Service Campaign Bulletin

Campaign No. 2013010001, February 2013

SUBJECT: **Model 207, 212, 218, 221, 231 with Engine M278, Model Year 2013
Remove Check Valve for Left and Right Secondary Chain Tensioners**

Figure 1 (model 231)

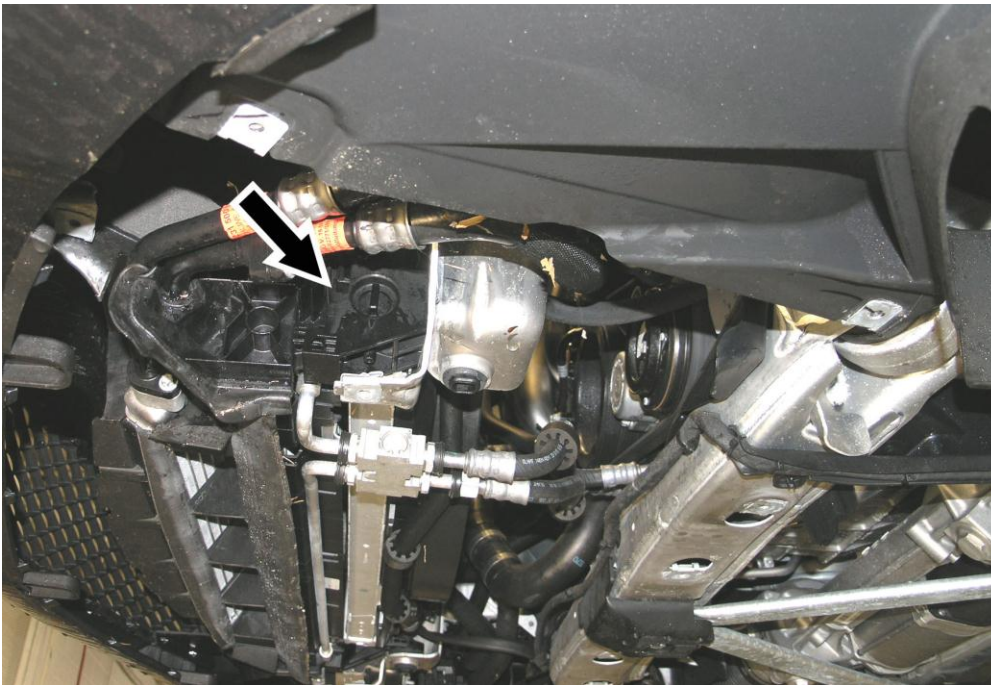
- Remove/install charge air ducts (refer to attached WIS document on page 6).
- Remove lower engine compartment panels, refer to WIS: AR61.020-P-1105RK.
- Drain coolant from radiator (arrow, Figure 1).

**Figure 3** (Shown on right side)**Note:**

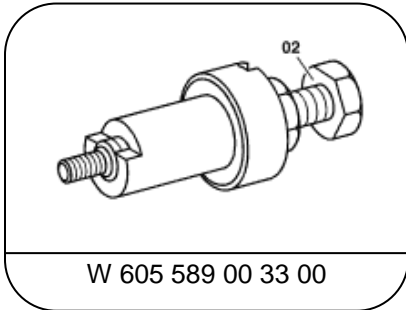
2. Remove check valve (A, Figure 3) with set puller (B) W 605 589 00 33 00 from cylinder head.

Cover chain case opening with rag so no parts can fall in.
